Interconnection Facilities Study Report

Request # GI-2006-1(i)

Cedar Creek Wind Energy, LCC
Facility Study

Customer Provided Comments Received 11/8/06

Figure 3: Engineering, Procurement & Construction Schedule

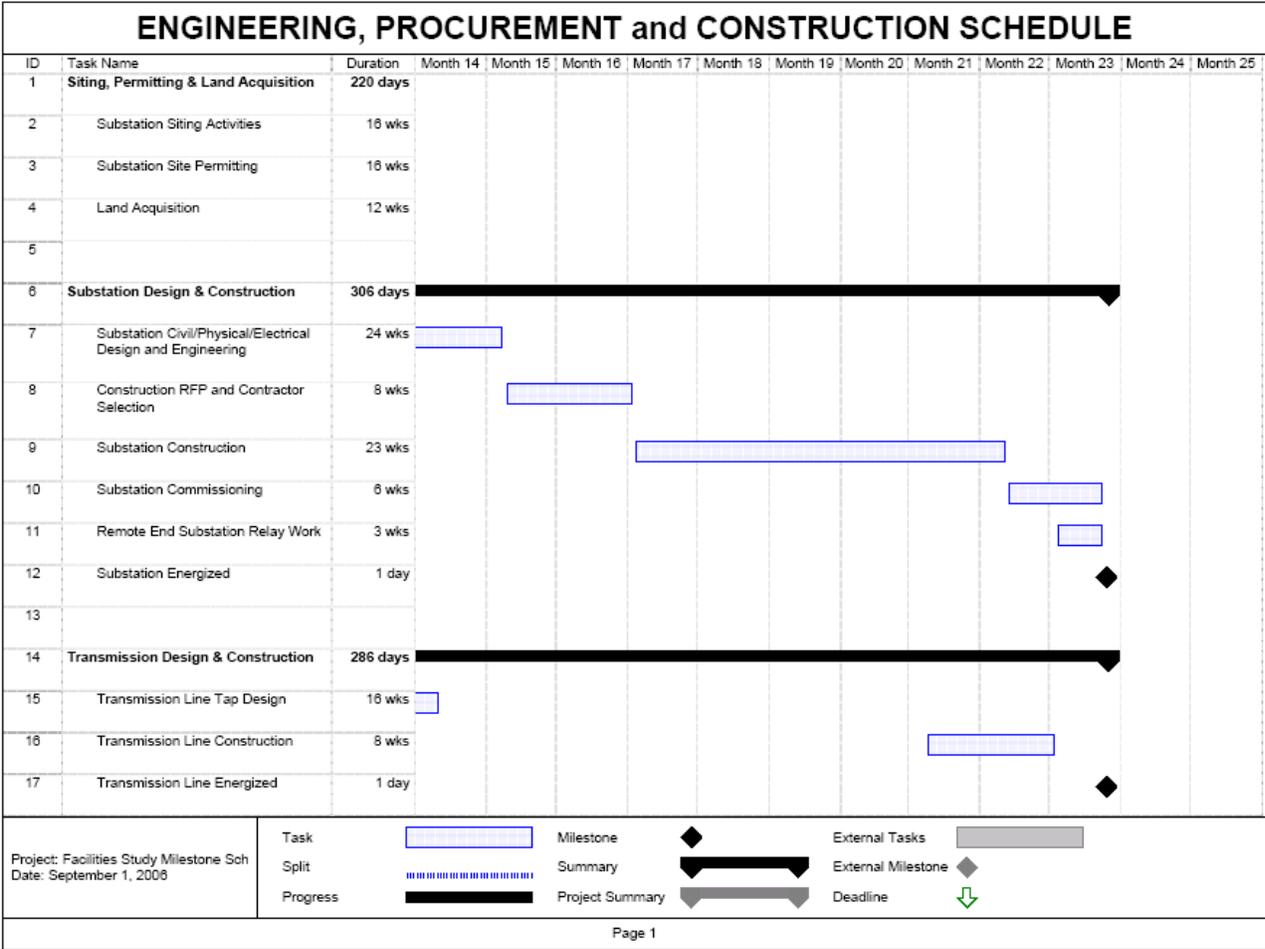
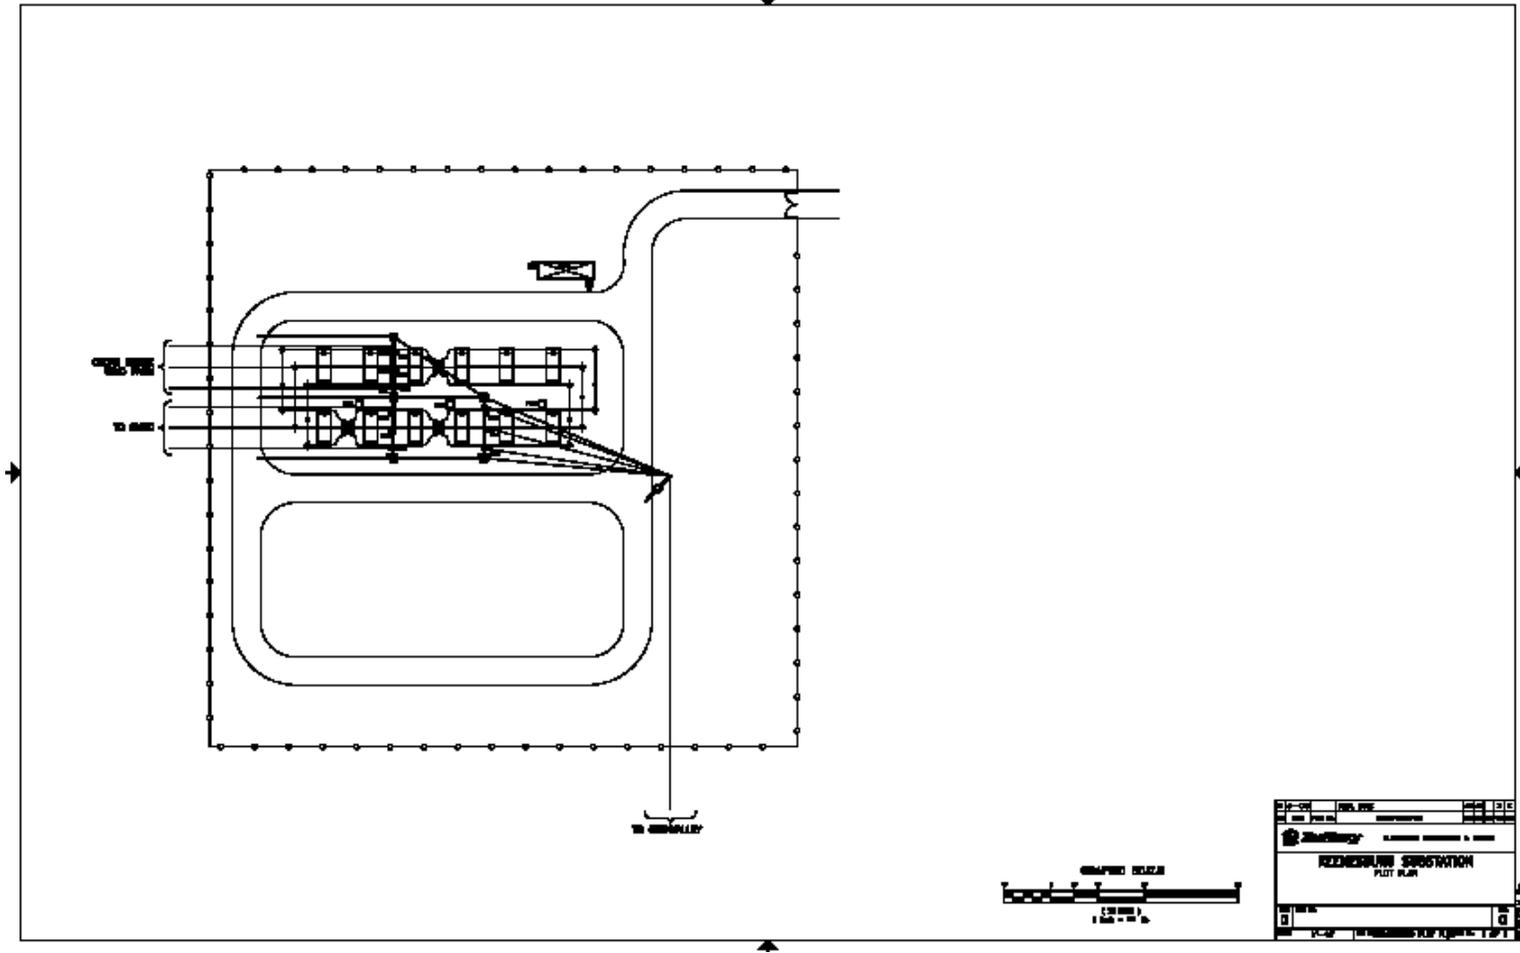
Section V indicates that the project is in approximately month 14 of a 23 month schedule – implying approximately 10 months until completion. Customer takes exception to this in that the LGIA states specifically a target completion date of 8 months after execution of the LGIA and completion of certain key payments and related milestones by the Customer.
